2016 SITE 8 AND SUQITUGHNEQ RIVER SURFACE WATER AND SEDIMENT SAMPLING REPORT

NORTHEAST CAPE ST. LAWRENCE ISLAND, ALASKA

FUDS No. F10AK0969-03

**Final
September 2017**

FIGURE NO:
A-6.1

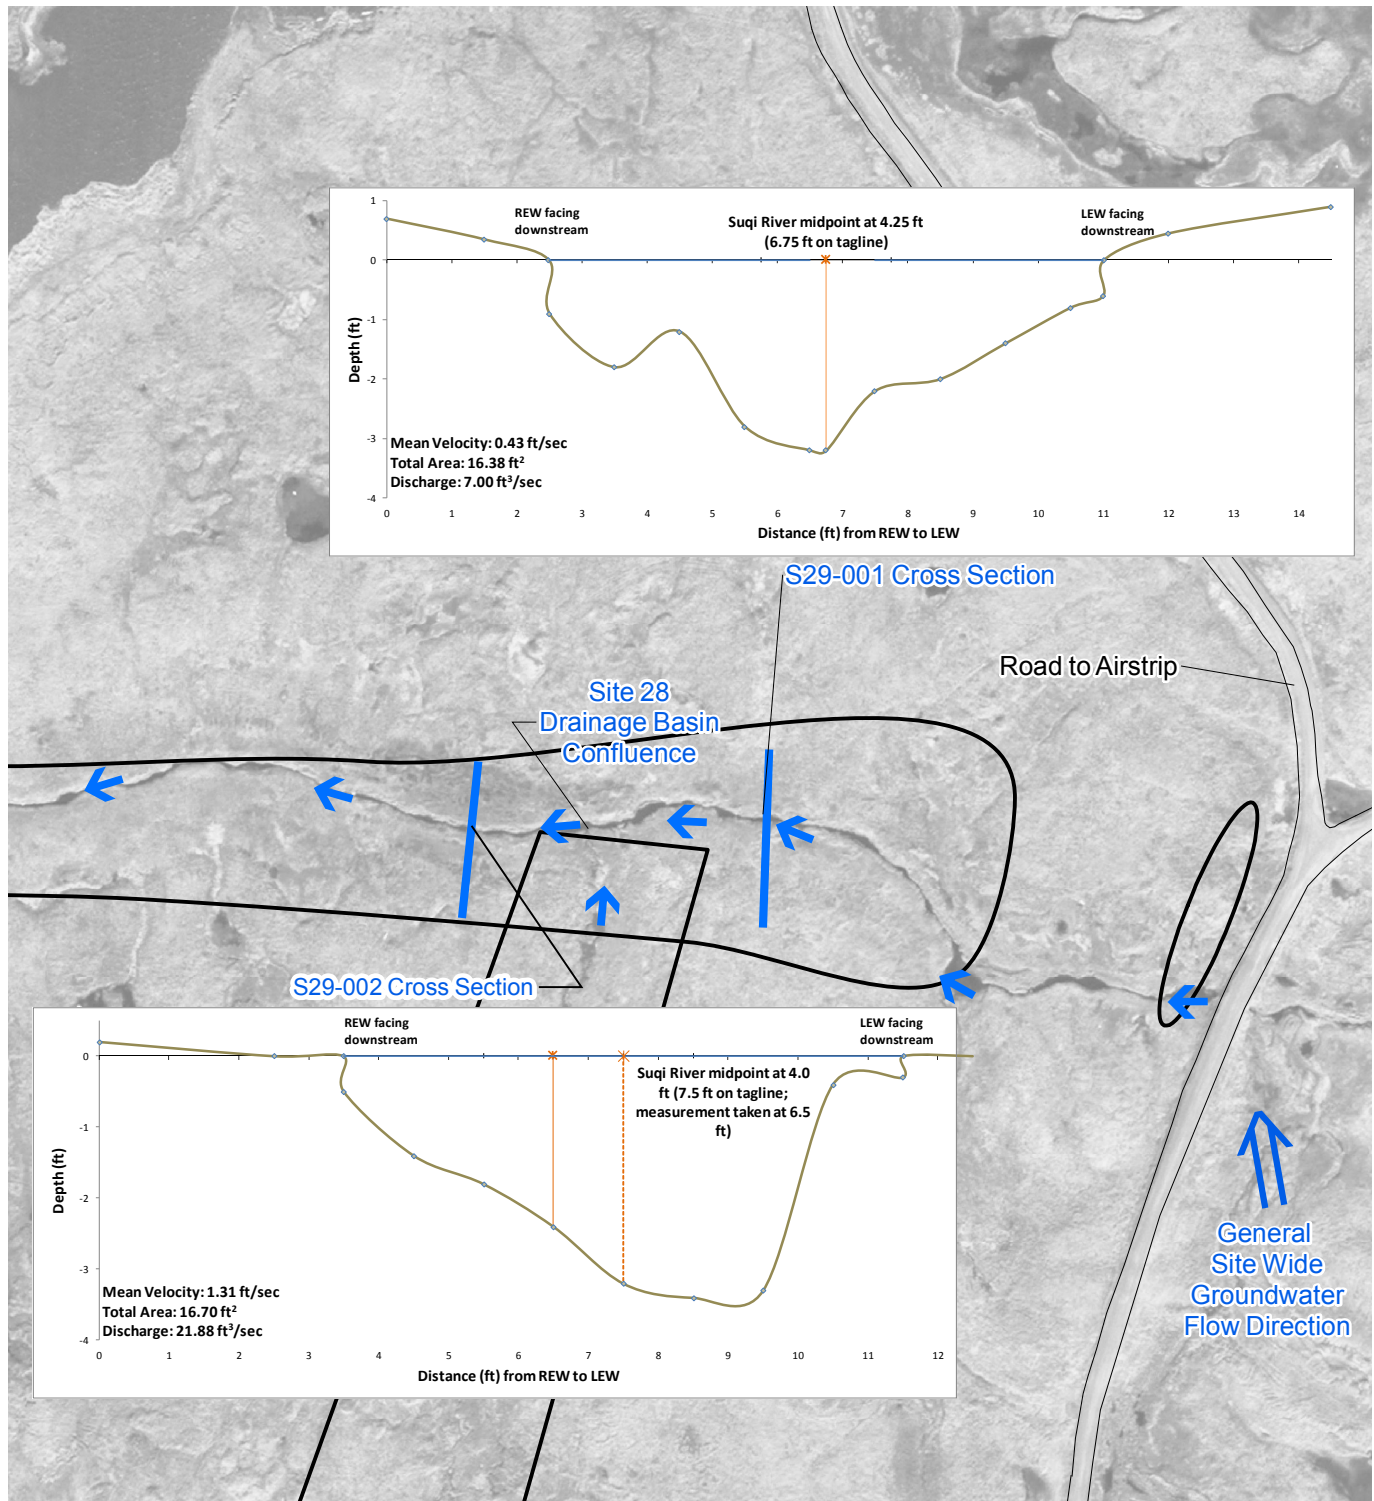
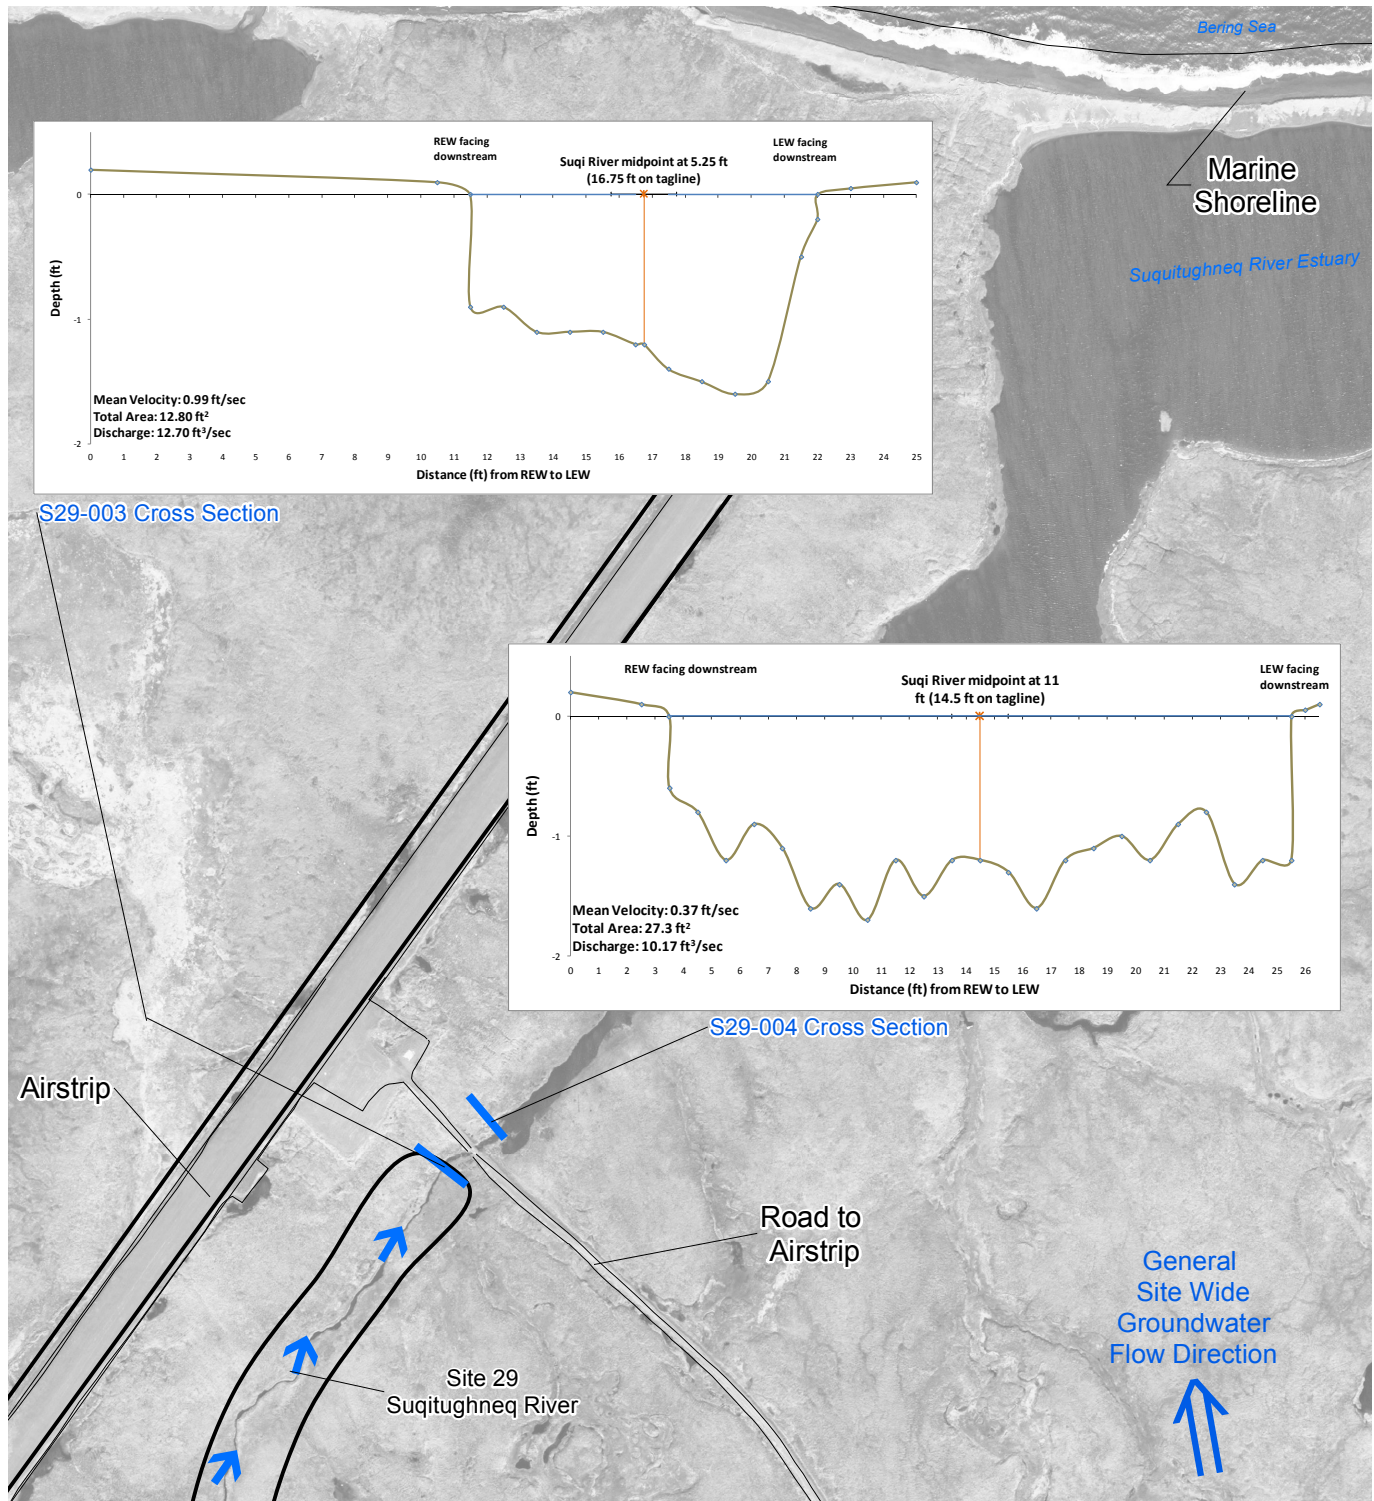
36.		Figure A-6	It would be helpful to provide an enhanced, closer aerial view/figure for the Site 28 Drainage Confluence Area and depict the different flow directions, river cross section data, etc.	Accepted. The extent for Figure A-6.1 will be zoomed in slightly while Figure A-6.2 will be zoomed in significantly. Additionally, arrows will
